## ORIGINATION FORM

### Proposed Revisions to a Standard Plans Index (Please provide all information — Incomplete forms will be returned)

Index Number: 455-060

Index Title: 60" Prestressed Concrete Cylinder Pile

INDEX  
455-060

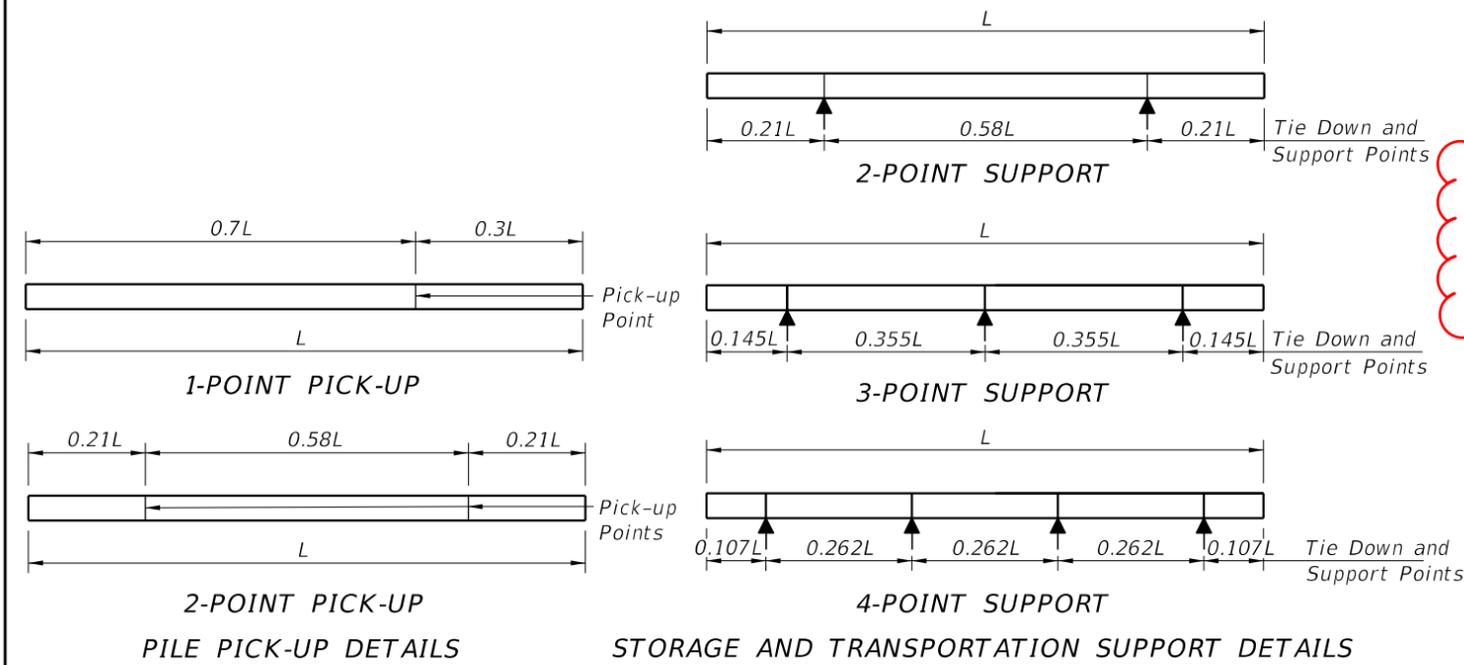
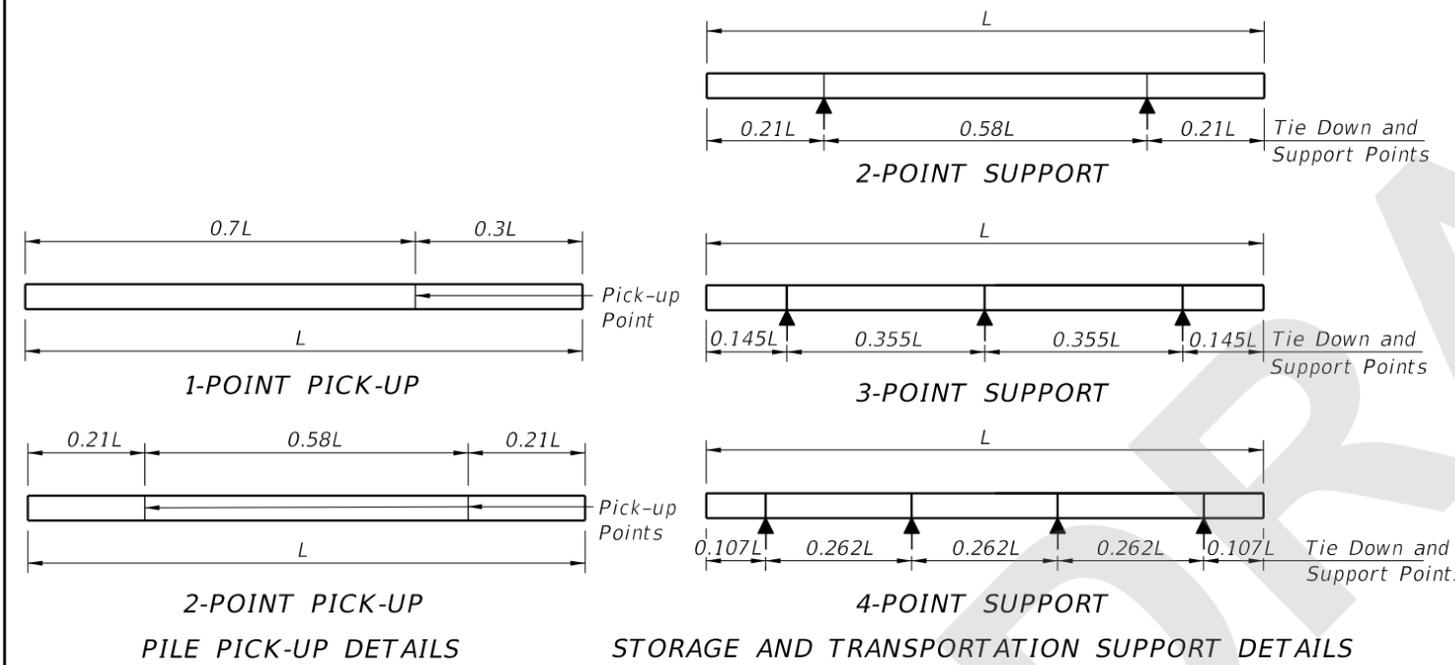
Change Silica Fume, metakaolin or ultra-fine flyash to Highly Reactive Pozzolans

Specification changed to fit silica fume, metakaolin and ultra-fine flyash under Highly Reactive Pozzolans

Highly Reactive Pozzolans

- Work this Index with the Pile Data Table in the Structures Plans.
- Concrete:
  - Piles: Class V (Special)
  - Splice Collar: Class IV
  - See "GENERAL NOTES" in the Structures Plans for locations where the use of Highly Reactive Pozzolans is required.
